DECISION/DIRECTION NOTE

Title: 164 Signal Hill Road
Single Detached Dwelling
DEV1900165

Date Prepared: February 18, 2020

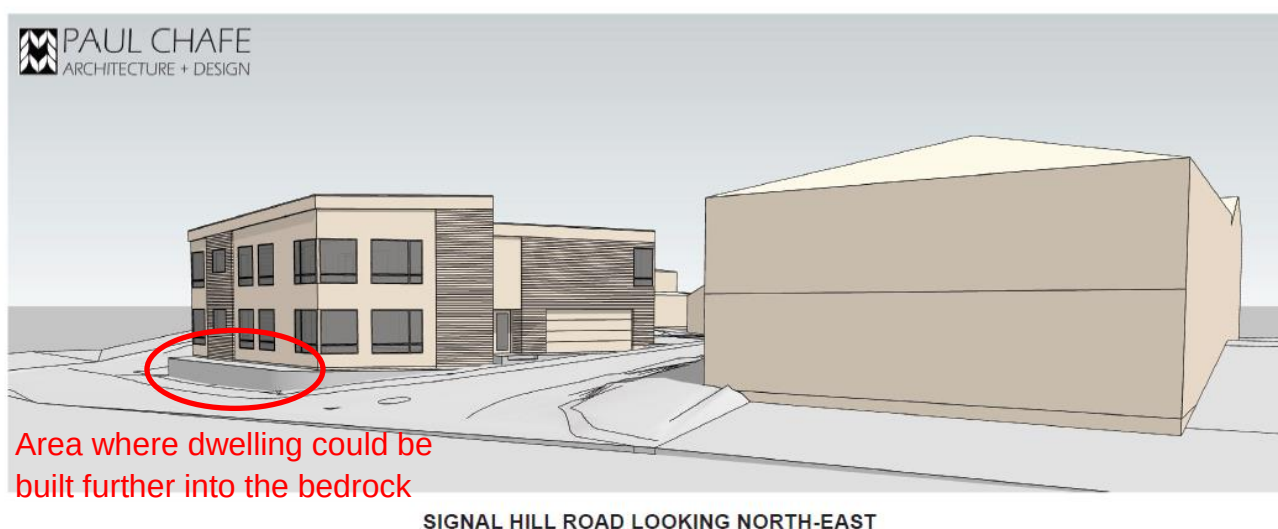
At the February 3, 2020 Council meeting, Council referred an application for a proposed dwelling at 164 Signal Hill Road to the Built Heritage Experts Panel (BHEP) for comment on the size of the building. The design of the building is not being presented or considered at this time. Renderings are submitted to display the height and mass of the proposed dwelling.

The BHEP reviewed the application at the February 12, 2020 meeting. The applicant and architect of the building attended the meeting. While the specifics of the design are not addressed in the BHEP's recommendation, the Panel provided initial comments on the design during the meeting to better inform the applicant prior to preparing detailed designs. For example, while the proposed flat roof is intended to mitigate issues on the views of

neighbouring properties, the Panel suggested that consideration be given to a low sloping gable or hipped roof, which would blend better with the character of the Battery. The Panel did not have any concerns regarding the size of the building (the footprint) or the building height of two storeys. However, the Panel recommends that the dwelling could be built further into the bedrock to reduce the impact on neighbouring properties. As proposed, the applicant has built the land up at the western side of Murphy's Right of Way to provide a consistent floor level across the dwelling (see drawing below). By lowering the entire development closer to the level of the road, the impact on neighbouring properties could be reduced while maintaining two storeys. Note, lowering the building may require adjustments to the garage along the southern side of Murphy's Right of Way.

- 1. The proposed building footprint is acceptable
- 2. A two-storey house is acceptable at this site, however,
 - a. The proposed overall height should be reduced to mitigate any negative impacts of view for neighbours;
 - b. The design should be changed to incorporate a low-sloping gable or hipped roof, in keeping with other houses in the neighbourhood.
 - c. The design, materials and windows should be in keeping with the character of the Battery Neighborhood.
